**Subject: Beaver Valley Power Station, Unit Nos. 1 and 2  
BV-1 Docket No. 50-334, License No. DPR-66  
BV-2 Docket No. 50-412, License No. NPF-73  
Responses to a Request for Additional Information (RAI dated May 21,  
2007) in Support of License Amendment Request Nos. 333 and 204 (TAC  
Nos. MD2377 MD2378)**

**REQUEST FOR ADDITIONAL INFORMATION**

**REGARDING THE SPENT FUEL POOL CRITICALITY**

**ANALYSIS LICENSE AMENDMENT REQUEST**

Figure 1 – Fresh Enrichment vs.  $k_{eff}$  for “All-Cell”

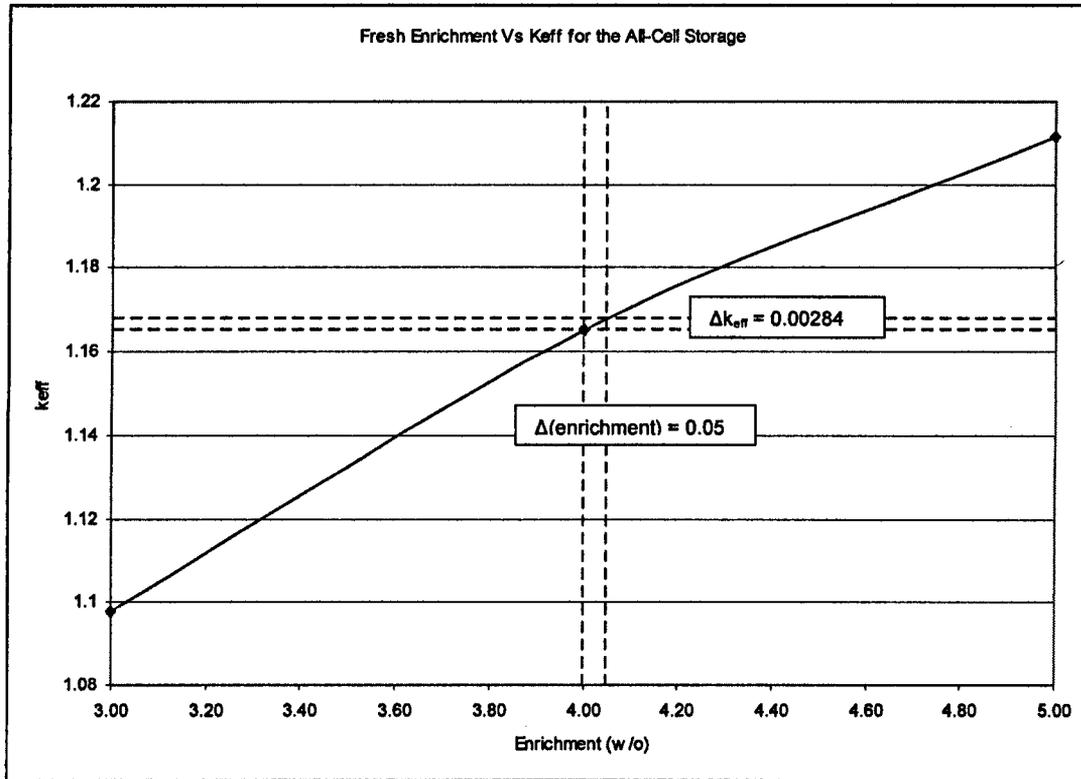
- v. **With respect to the U235 enrichment uncertainty, the footnote does not provide sufficient information to make an assessment of adequacy of the value in the table. Provide a detailed explanation of how the U235 enrichment uncertainty was determined.**

The  $k_{\text{eff}}$  values were evaluated at 3.0, 4.0, and 5.0 w/o  $^{235}\text{U}$  fresh enrichments, and the  $\Delta k_{\text{eff}}/\Delta(\text{Enrichment})$  was evaluated at  $(4.0 + 0.05)$  w/o  $^{235}\text{U}$  using the 2<sup>nd</sup> order polynomial passing through the 3 data points as shown on Figure 1.

Figure 2 – Burnup vs.  $k_{eff}$  at 5.0 w/o  $^{235}\text{U}$  for “All-Cell”

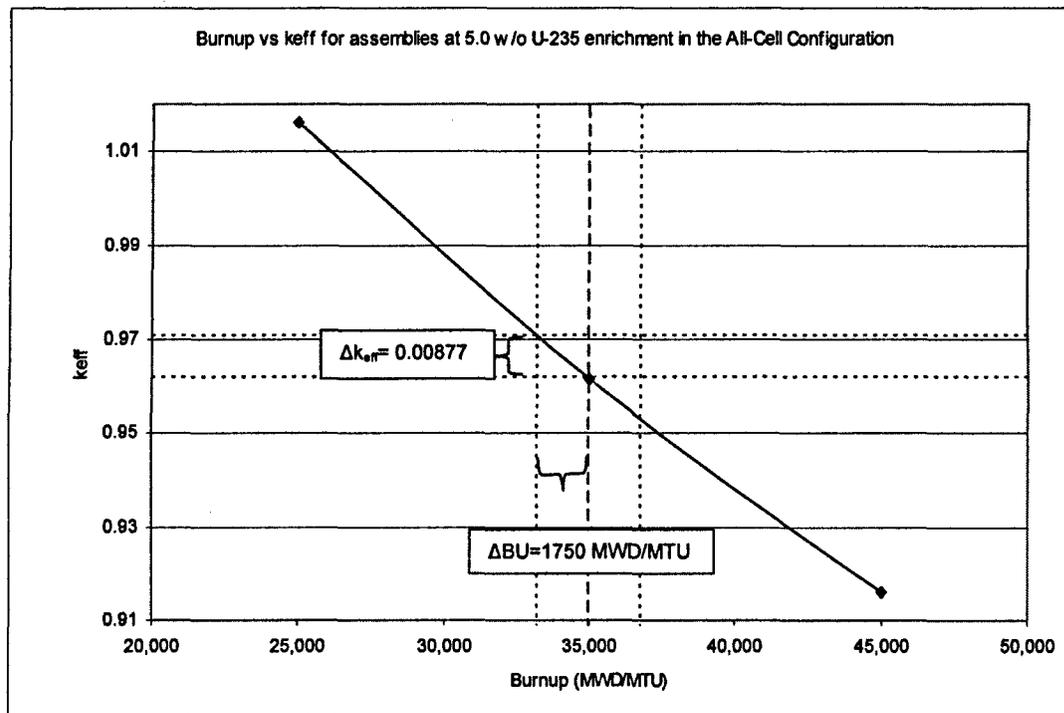
- vi. With respect to the burnup uncertainty, the footnote does not provide sufficient information to make an assessment of adequacy of the value in the table. Provide a detailed explanation of how the burnup uncertainty was determined.

A 5% burnup measurement uncertainty is applied by evaluating the differential burnup worths at the conservative maximum burnup credited value of 35,000 MWD/MTU with 5.0 w/o  $^{235}\text{U}$  initial enrichment for the “All-Cell” Configuration. Figure 2 shows the  $k_{eff}$  values at the highest burnup limit of 35000 MWD/MTU and 33250 (=35000 – 35000\*5%) MWD/MTU and the  $\Delta k_{eff}$  is calculated between these two points. For further explanation please see response to RAI question 19 (a) (vii).

Figure 3 – Burnup vs.  $k_{eff}$  for peripheral assemblies in the 3x3 Configuration

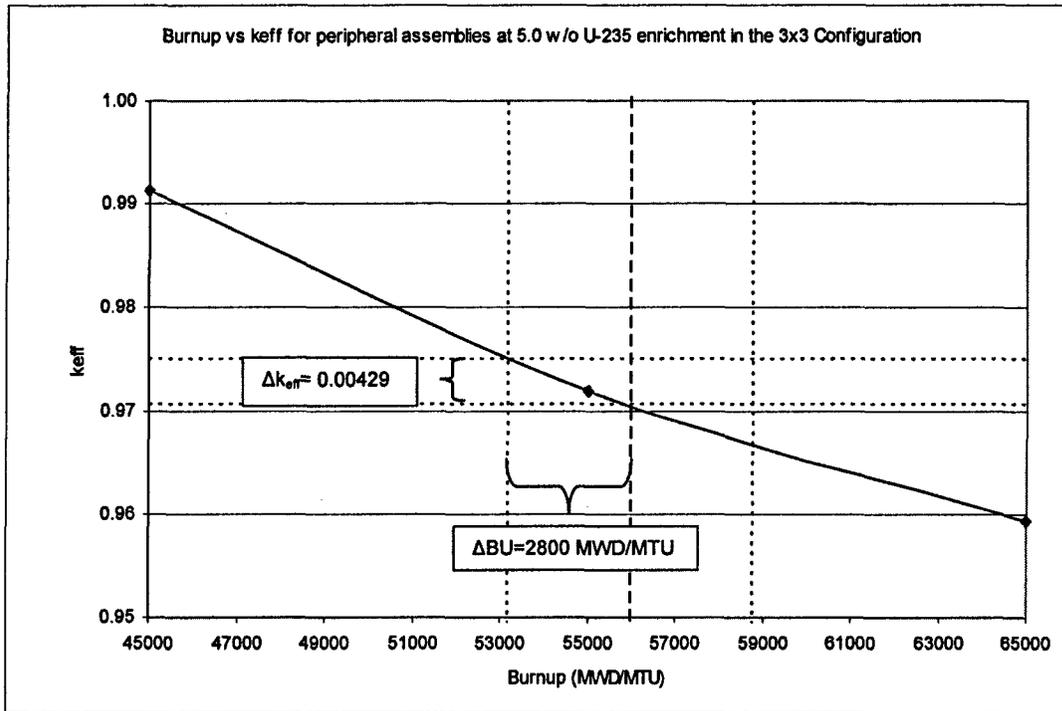
- vi. **With respect to the burnup uncertainty, the footnote does not provide sufficient information to make an assessment of adequacy of the value in the table. Provide a detailed explanation of how the burnup uncertainty was determined.**

A 5% burnup measurement uncertainty is applied by evaluating the differential burnup worths at the conservative maximum burnup credited value of 56,000 MWD/MTU with 5.0 w/o  $^{235}\text{U}$  initial enrichment for the peripheral assemblies in the "3x3" configuration. Figure 3 shows the  $k_{\text{eff}}$  values at the highest burnup limit of 56,000 MWD/MTU and 53,200 (=56,000 - 56,000\*5%) MWD/MTU and the  $\Delta k_{\text{eff}}$  is calculated between these two points. For further explanation please see response to RAI question 19 (a) (vii).

Figure 4 – Enrichment vs.  $k_{\text{eff}}$  for 1-out-of-4

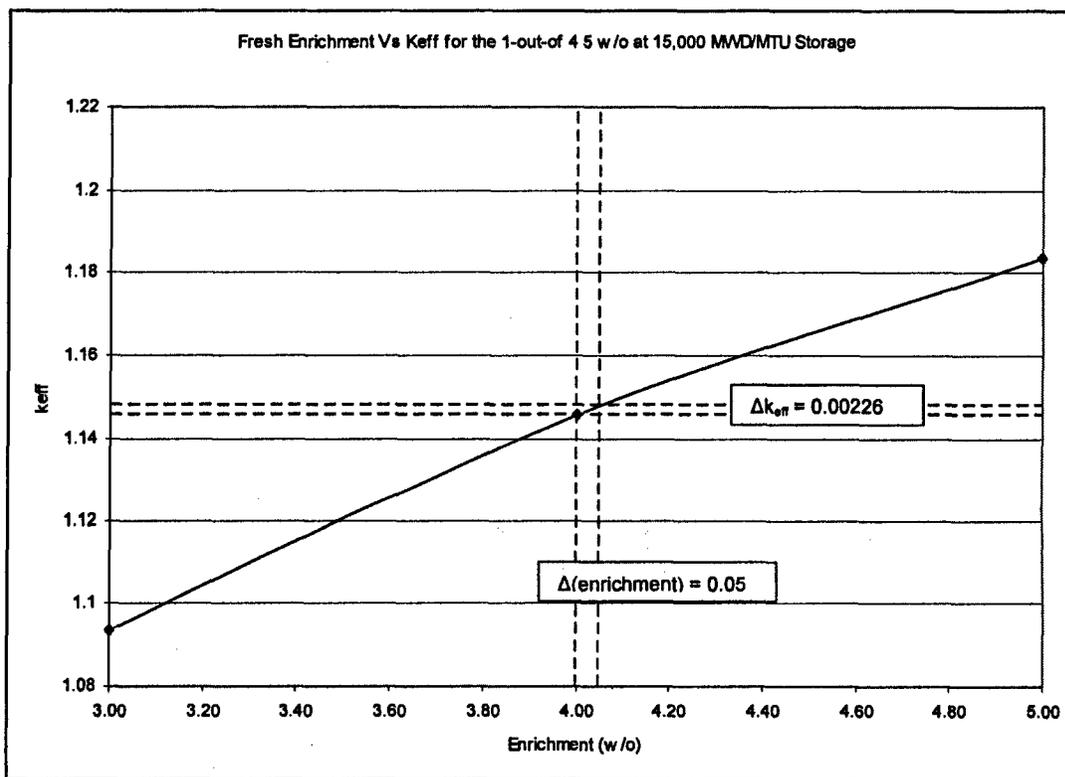
- v. **With respect to the U235 enrichment uncertainty, the footnote does not provide sufficient information to make an assessment of adequacy of the value in the table. Provide a detailed explanation of how the U235 enrichment uncertainty was determined.**

The  $k_{\text{eff}}$  values were evaluated at 3.0, 4.0, and 5.0 w/o  $^{235}\text{U}$  fresh enrichments, and the  $\Delta k_{\text{eff}}/\Delta(\text{Enrichment})$  was evaluated at  $(4.0 + 0.05)$  w/o  $^{235}\text{U}$  using the 2<sup>nd</sup> order polynomial passing through the 3 data points, while one of the assemblies was kept at 5.0 w/o, 15,000 MWD/MTU. See Figure 4.

Figure 5 – Burnup vs.  $k_{\text{eff}}$  at 5.0 w/o  $^{235}\text{U}$  1-out-of-4

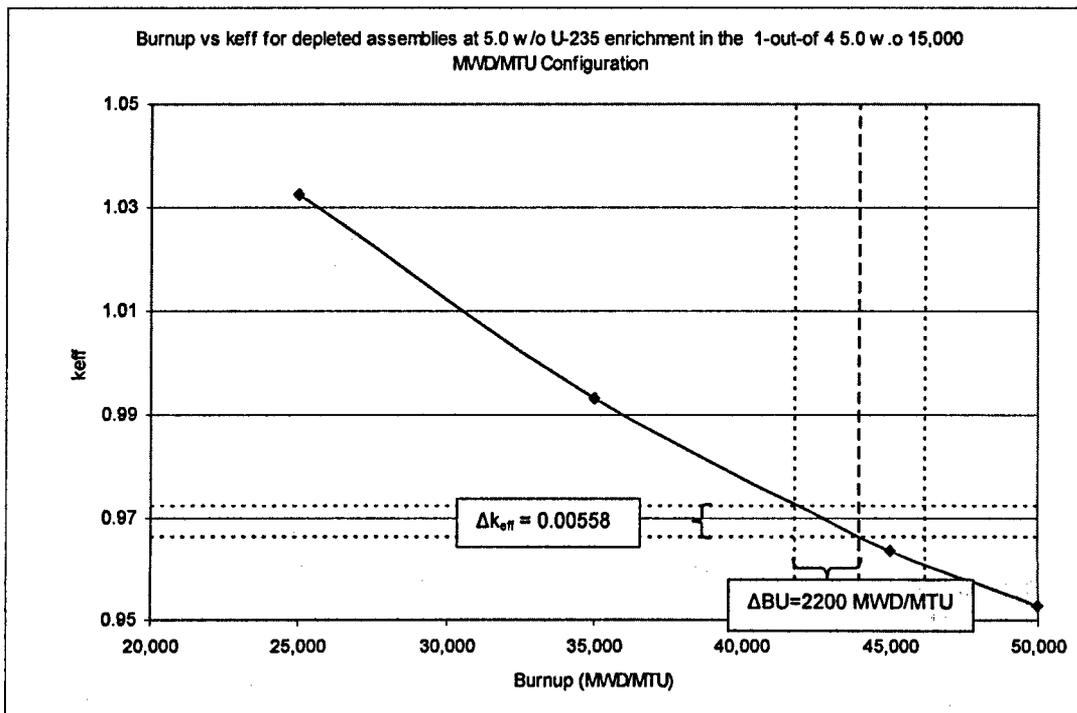
- vi. **With respect to the burnup uncertainty, the footnote does not provide sufficient information to make an assessment of adequacy of the value in the table. Provide a detailed explanation of how the burnup uncertainty was determined.**

A 5% burnup measurement uncertainty is applied by evaluating the differential burnup worths at the conservative maximum burnup credited value of 44,000 MWD/MTU with 5.0 w/o  $^{235}\text{U}$  initial enrichment for the "1-out-of-4 5.0 w/o at 15,000 MWD/MTU" configuration. Using the burnup vs.  $k_{\text{eff}}$  curve,  $k_{\text{eff}}$  values at the highest burnup limit of 44000 MWD/MTU and 41800 (=44000 - 44000\*5%) MWD/MTU are determined and the  $\Delta k_{\text{eff}}$  is calculated between these two points. For further explanation please see response to RAI question 19 (a) (vii).
